Access Compliance Report

Public Rights-of-Way

Intersection ID: 13780	Main Street: ELIZABETH_AV	Cross Street: N_TORRENCE_ST	Location: S
ADA ID: 79E3BC2D3AC6	Ramp Type: Perp	Initial Pass/Fail: Fail	Overall Compliance: No
		Severity Score: 8.75

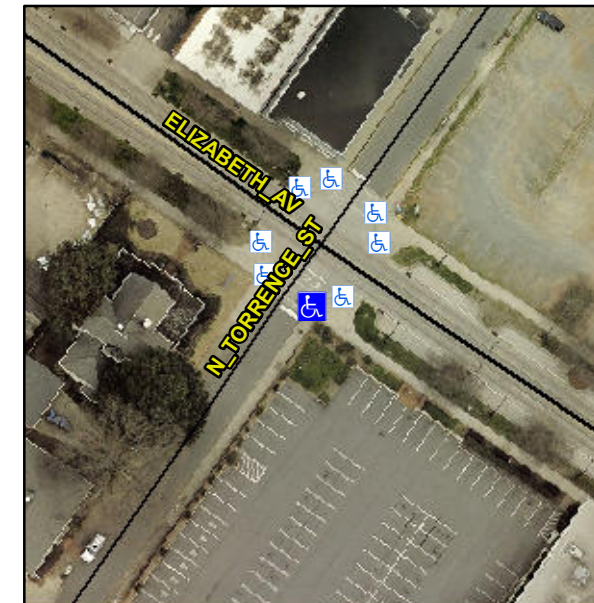
Not Found, R304.5.1

Compliance	Description	Data	Compliance	Description	Data
N/A	Ramp Length (in)	76.0	Yes	Ramp Slope (%)	8.1
No	Ramp Width (in)	47.5	Yes	Ramp XSlope (%)	1.7
N/A	Flare Type LT	N/A	N/A	Flare Type RT	N/A
N/A	Flare Slope LT (%)	N/A	N/A	Flare Slope RT (%)	N/A
N/A	Flare Traversable LT?	N/A	N/A	Flare Traversable RT?	N/A
N/A	Landing Length (in)	N/A	N/A	DWS Provided?	N/A
N/A	Landing Width (in)	N/A	N/A	DWS Contrast?	N/A
N/A	Landing Slope (%)	N/A	N/A	DWS Length (in)	N/A
N/A	Landing X Slope (%)	N/A	N/A	DWS Full Width?	N/A
N/A	Landing Curb? (Y/N)	N/A	N/A	DWS Offset (in)	N/A
N/A	Shared Landing?	N/A			
N/A	Gutter Ponding?	N/A	N/A	Gutter Slope (%)	N/A
N/A	Gutter Lip Ht (in)	N/A	N/A	Gutter X Slope (%)	N/A
N/A	Painted X Walk1?	Yes	N/A	Painted X Walk2?	N/A
	X Walk 1 Direction	To NW		X Walk 2 Direction	N/A
N/A	X Walk 1 Width (in)	116.0	N/A	X Walk 2 Width (in)	N/A
	X Walk 1 Slope (%)	3.1		X Walk 2 Slope (%)	N/A
	X Walk 1 X Slope (%)	0.2		X Walk 2 X Slope (%)	N/A

Remove & Replace Entire Ramp.
